P&Z CASE # SP2022-043 P&Z DATE 09/13/2022 CC DATE \_\_\_\_\_ Approved/Denied

PROJECT NUMBER: SP2022-043  
PROJECT NAME: Site Plan for 607 White Hills Drive  
SITE ADDRESS/LOCATIONS: 607 WHITE HILLS DR

CASE CAPTION: Discuss and consider a request by Paul Cragun of Cumulus Design on behalf of Campfire Shops, LLC for the approval of a Site Plan for a Carwash, Restaurant, and Commercial/Retail Shopping Center on a 2.003-acre parcel of land identified Lot 4, Block A, Wal-Mart Super Center Addition, City of Rockwall, Rockwall County, Texas, zoned Commercial (C) District, situated within the IH-30 Overlay (IH-30 OV) District, situated along the east side of White Hills Drive south of Suncrest Drive, and take any action necessary.

DEPARTMENT	REVIEWER	DATE OF REVIEW	STATUS OF PROJECT
PLANNING	Bethany Ross	08/26/2022	Approved w/ Comments

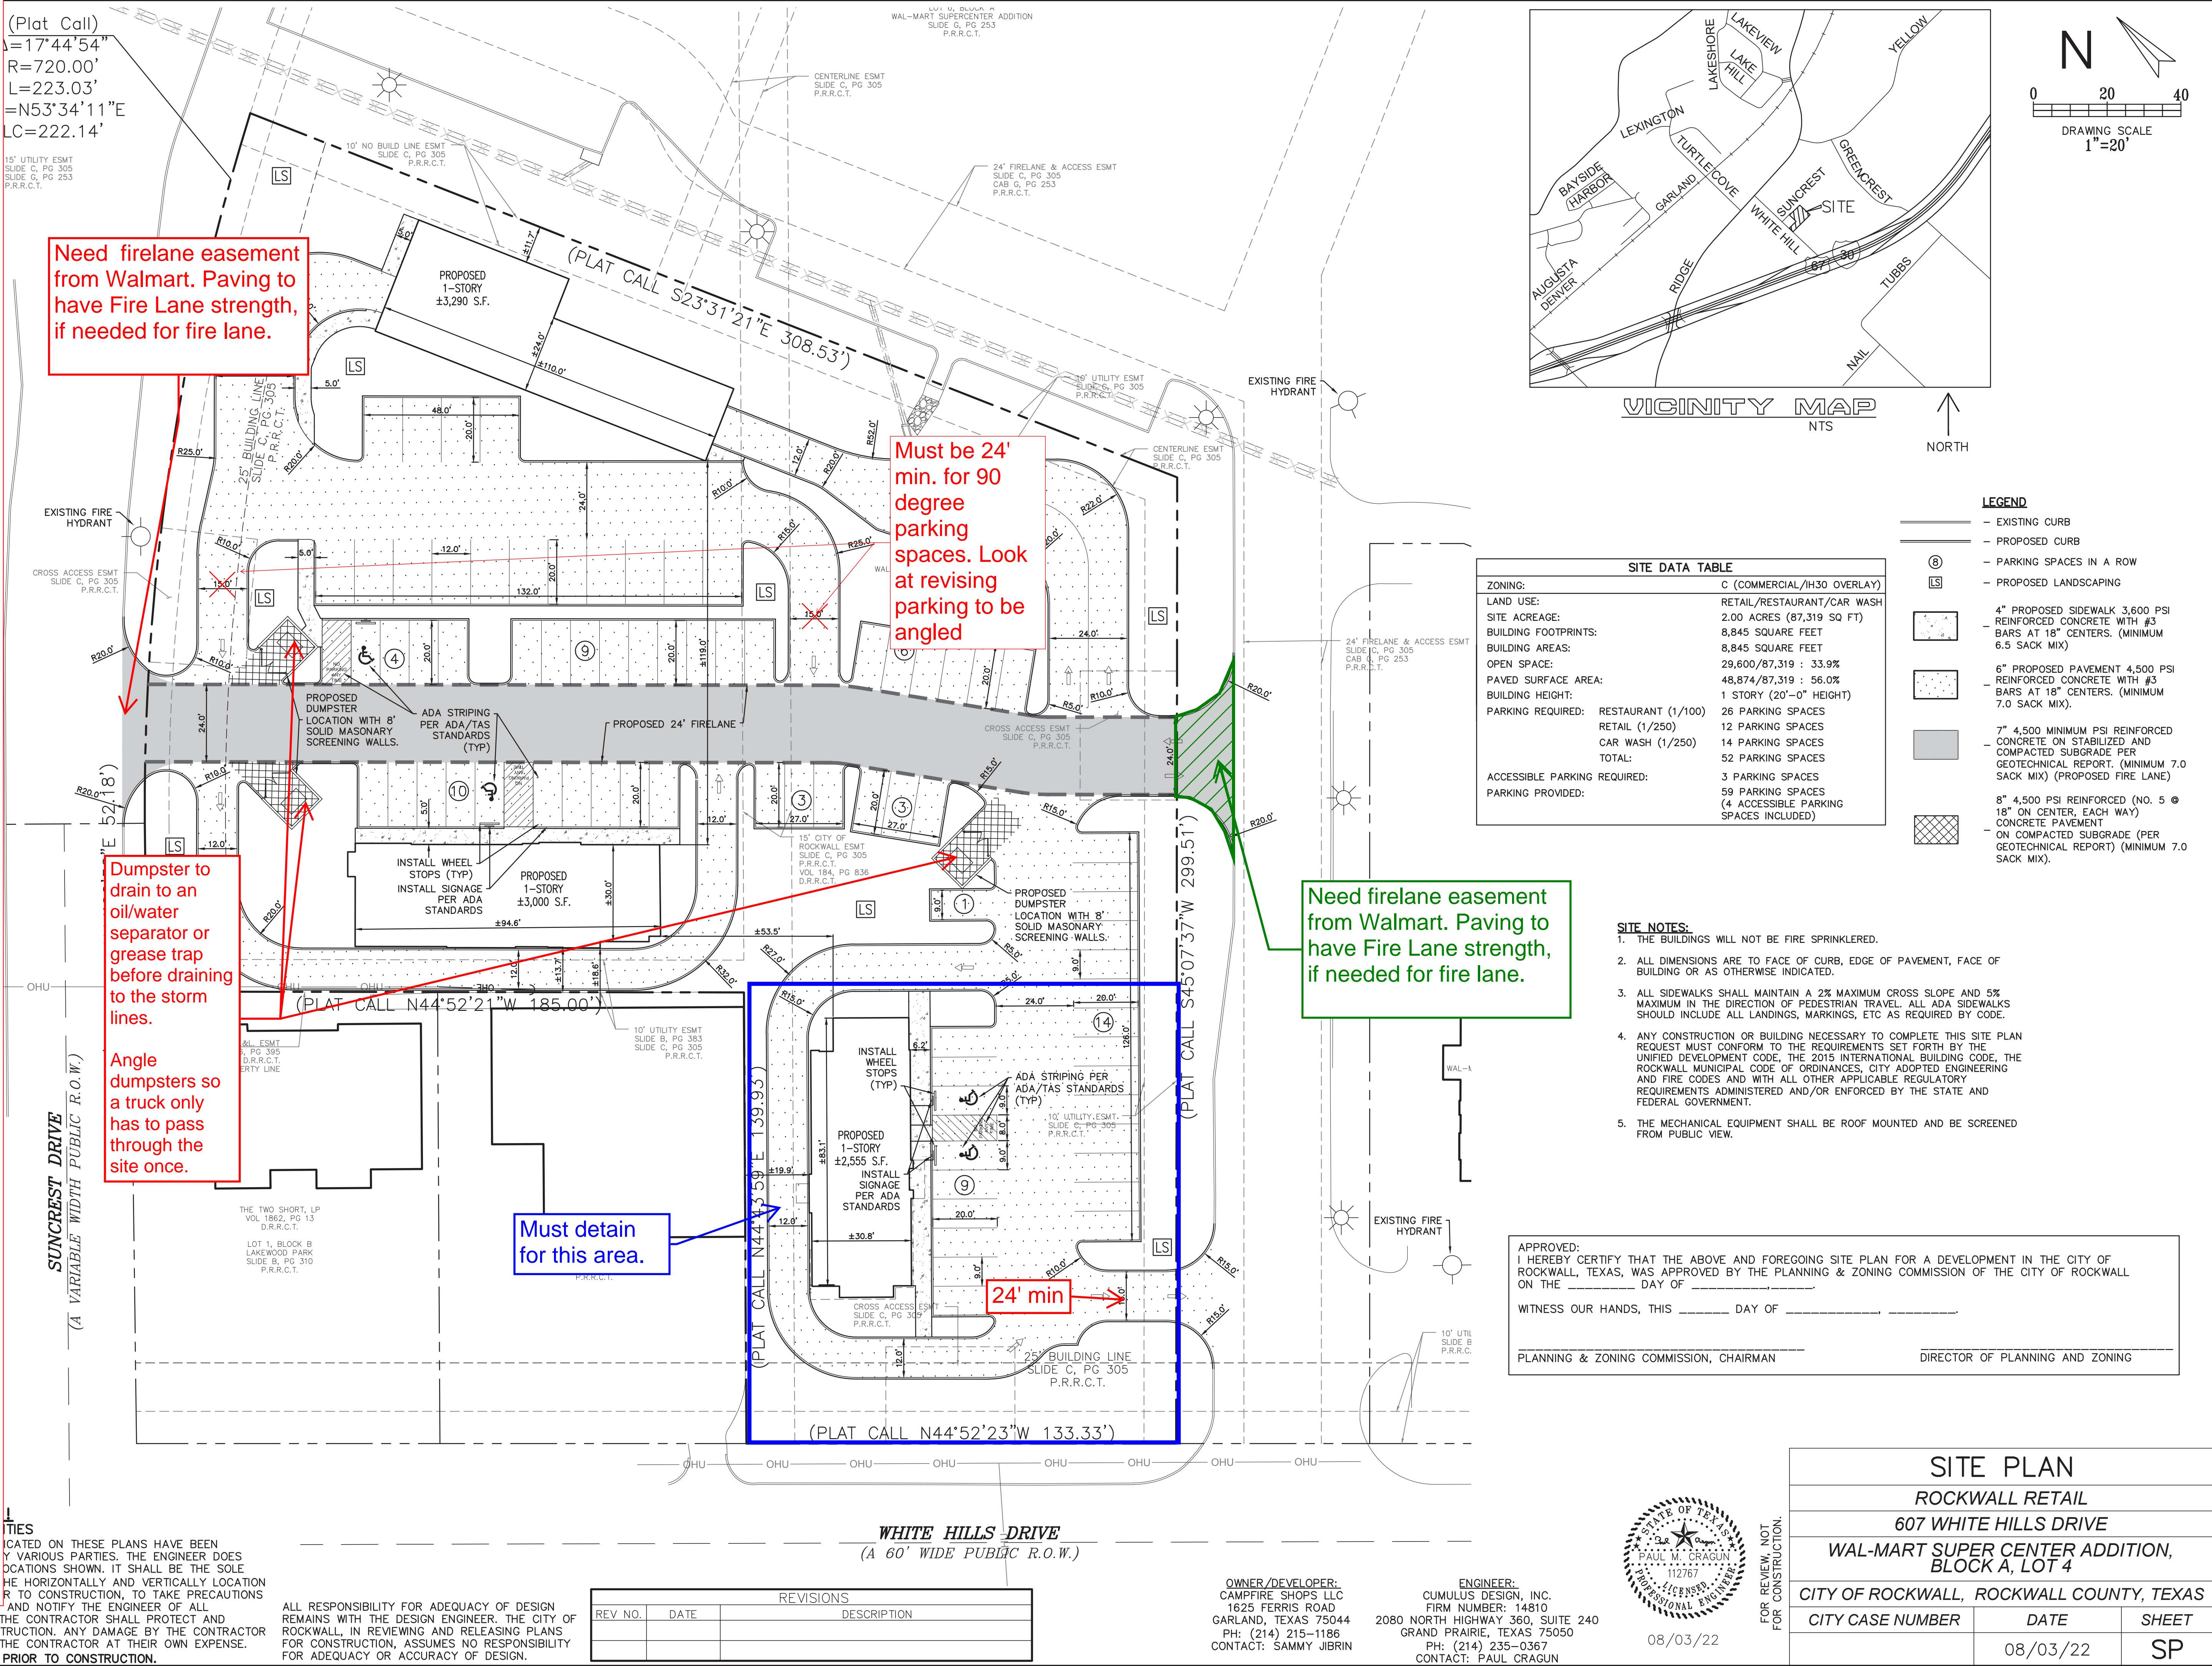
- General Items:**
- Must meet City Standards of Design and Construction
  - 4% Engineering Inspection Fees
  - Impact Fees (Water, Wastewater & Roadway)
  - Minimum easement width is 20' for new easements. No structures allowed in easements.
  - Retaining walls 3' and over must be engineered.
  - All retaining walls must be rock or stone face. No smooth concrete walls.

- Drainage Items:**
- Detention is required for blue box shown.

- Water and Wastewater Items:**
- Existing and proposed water, sewer, and detention area must be shown on site plan
  - May need an 8" looped water line through the site if the below criteria isn't meet
  - Only one "use" can be off a dead-end water line (Domestic service, irrigation, fire hydrant, or fire line).
  - May need a fire hydrant (check with the fire marshal's office)
  - Dumpster area to drain to an oil/water separator or grease trap before draining to the storm lines.
  - Before abandoning sewer, must camera sewer line to verify that there are no services that connect to the line. Video must be provided to the City with signed/sealed letter from the design engineer.
